Access Compliance Report

Public Rights-of-Way

(Curb Ramps)

Intersection ID: 11425	Main Street: AVENING_CT	Cross Street: AVENSONG_CROSSING_DR	Location: SW
ADA ID: 36470D3818CB	Ramp Type: Perp	Initial Pass/Fail: Fail	Overall Compliance: No
Severity Score: 8.75			
Codes/Mitigation Info/Possible Solution		Field Measurements/Component Compliance

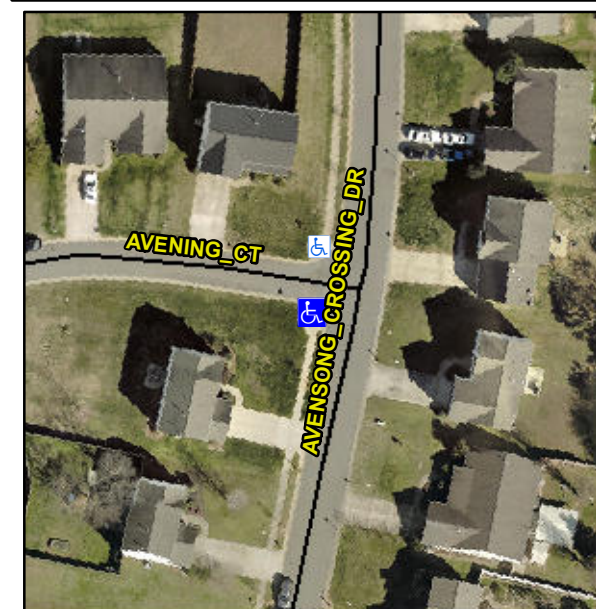
Not Found, R304.5.1

Compliance	Description	Data	Compliance	Description	Data
N/A	Ramp Length (in)	48.5	Yes	Ramp Slope (%)	5.3
No	Ramp Width (in)	45.5	Yes	Ramp XSlope (%)	0.7
N/A	Flare Type LT	N/A	N/A	Flare Type RT	N/A
N/A	Flare Slope LT (%)	N/A	N/A	Flare Slope RT (%)	N/A
N/A	Flare Traversable LT?	N/A	N/A	Flare Traversable RT?	N/A
N/A	Landing Length (in)	N/A	N/A	DWS Provided?	N/A
N/A	Landing Width (in)	N/A	N/A	DWS Contrast?	N/A
N/A	Landing Slope (%)	N/A	N/A	DWS Length (in)	N/A
N/A	Landing X Slope (%)	N/A	N/A	DWS Full Width?	N/A
N/A	Landing Curb? (Y/N)	N/A	N/A	DWS Offset (in)	N/A
N/A	Shared Landing?	N/A			
N/A	Gutter Ponding?	N/A	N/A	Gutter Slope (%)	N/A
N/A	Gutter Lip Ht (in)	N/A	N/A	Gutter X Slope (%)	N/A
N/A	Painted X Walk1?	No	N/A	Painted X Walk2?	N/A
	X Walk 1 Direction	To N		X Walk 2 Direction	N/A
N/A	X Walk 1 Width (in)	N/A	N/A	X Walk 2 Width (in)	N/A
	X Walk 1 Slope (%)	0.2		X Walk 2 Slope (%)	N/A
	X Walk 1 X Slope (%)	3.1		X Walk 2 X Slope (%)	N/A

Remove & Replace Entire Ramp.
